BID MEMO 01

<u>Saints - Cafeteria & Viewing Area</u>

REVISION #01

New Orleans Saints Viewing Area and Cafeteria Expansion 5800 Airline Drive Metairie, Louisiana 70003

1 SECOND FLOOR & LOW ROOF FRAMING PLAN S3.0 1/8" = 1'-0"

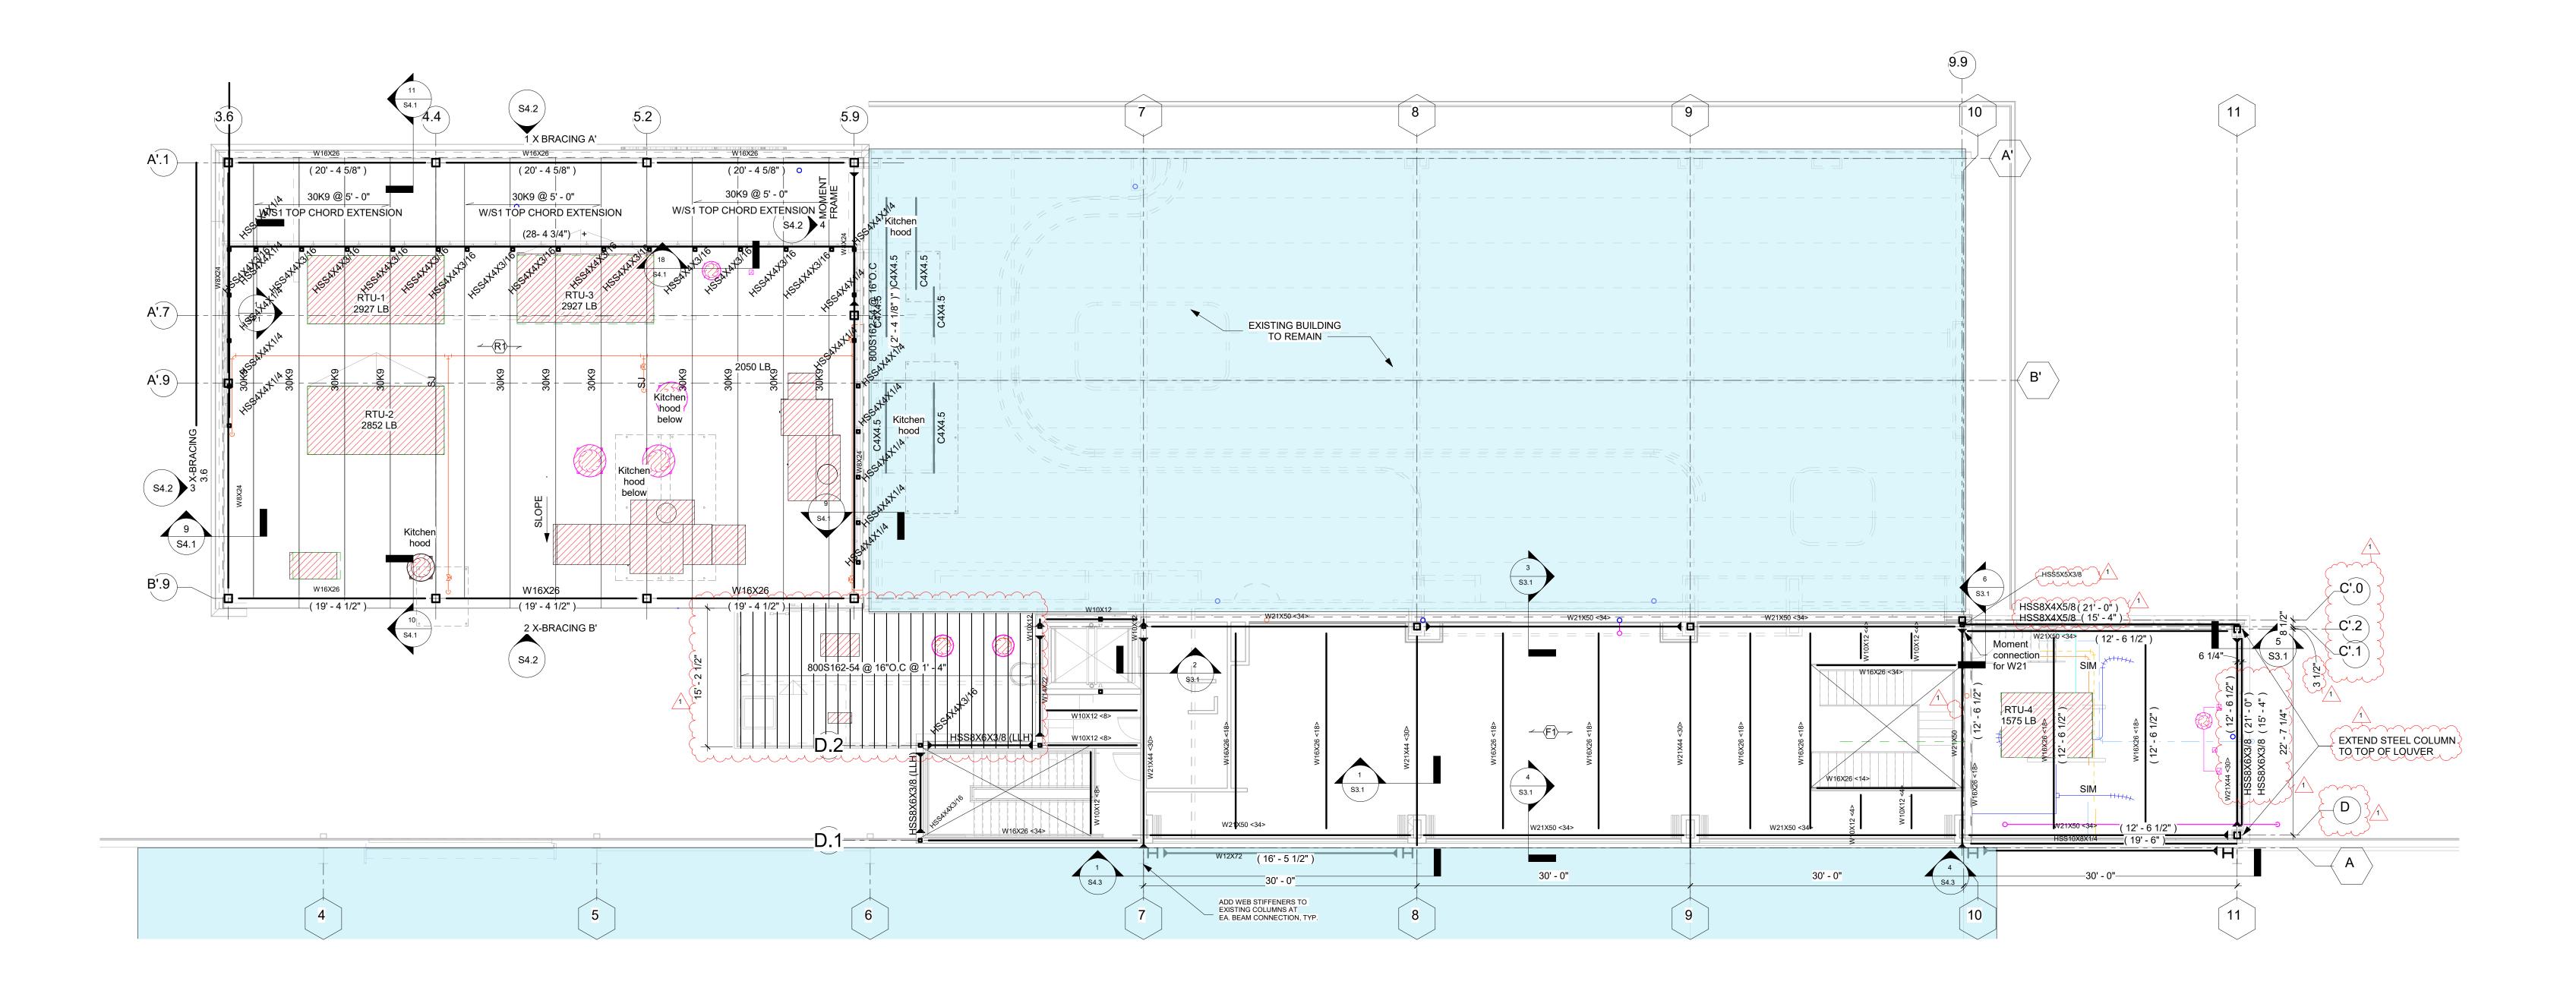
- 4 steel columns added for openings at indoor practice field S1.0
- Metal studs design for storage & electrical room at roof S3.0
- Structural post engineered for louvers at concrete mechanical platform & above new kitchen S3.0

1 HIGH ROOF FRAMING PLAN

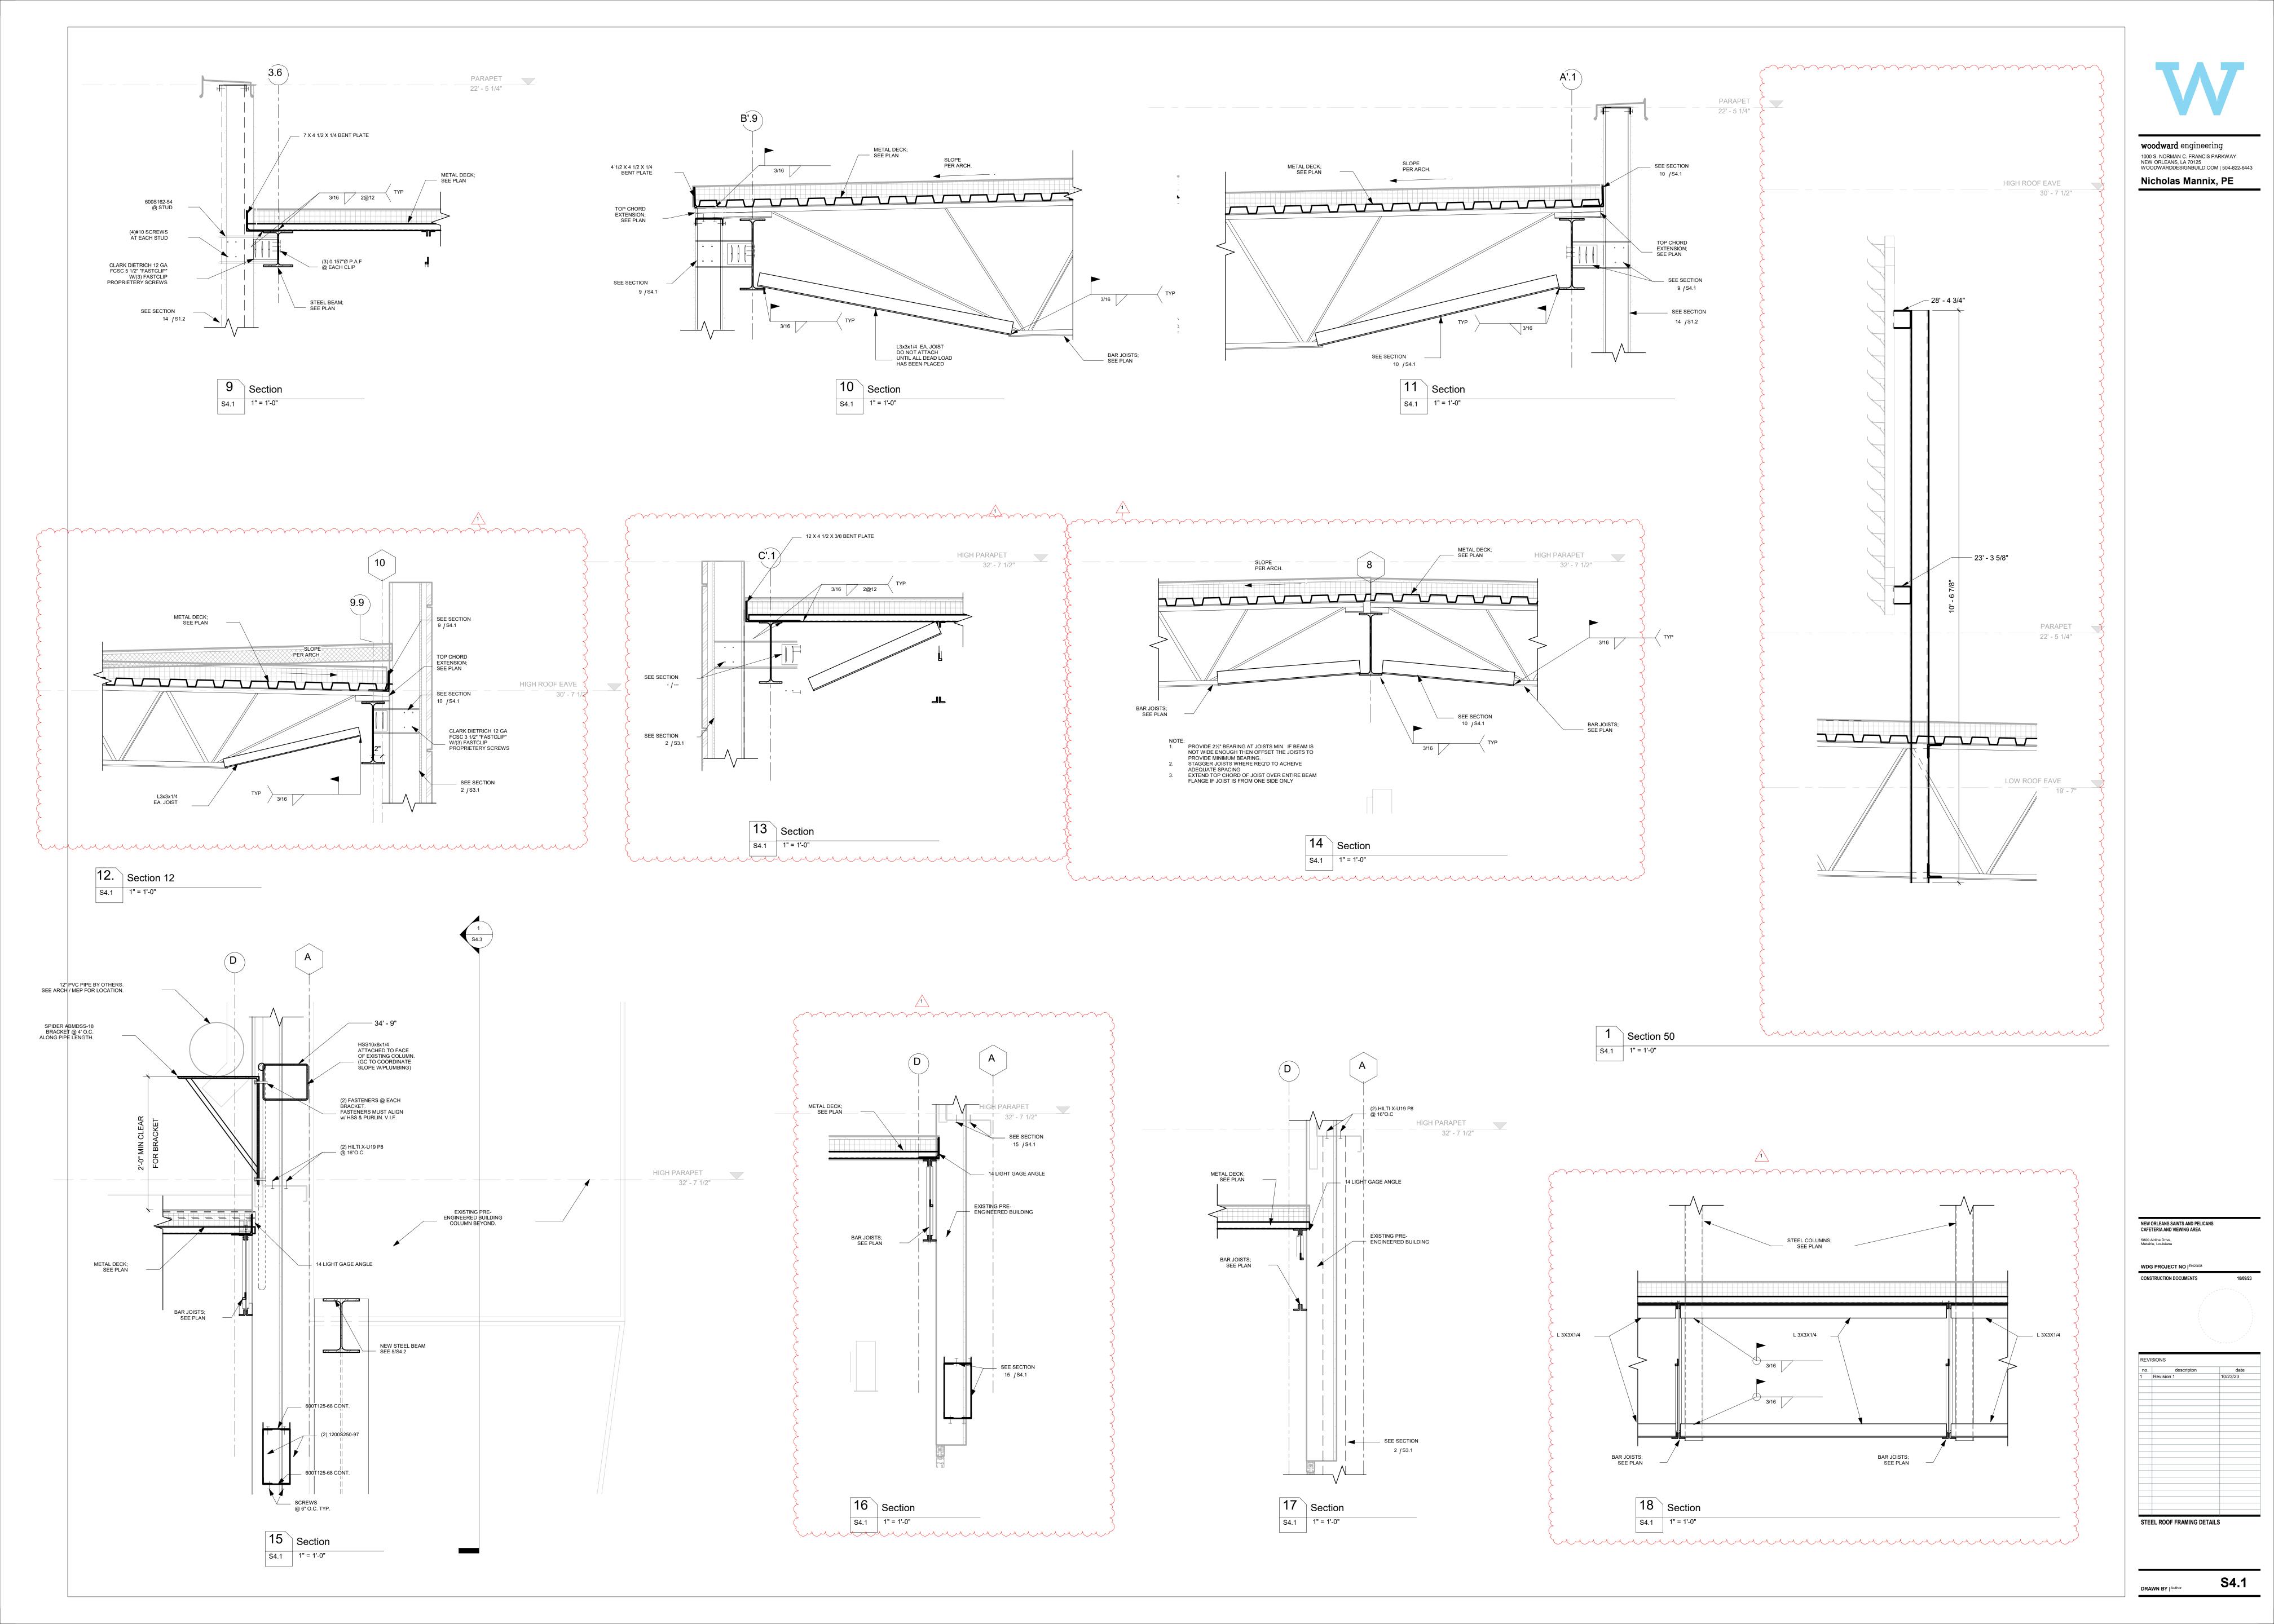
- Structural post details added at mechanical platform along with valley gutter detail S3.1
- Structural high roof frmaing plan beam sizes adjusted S4.0
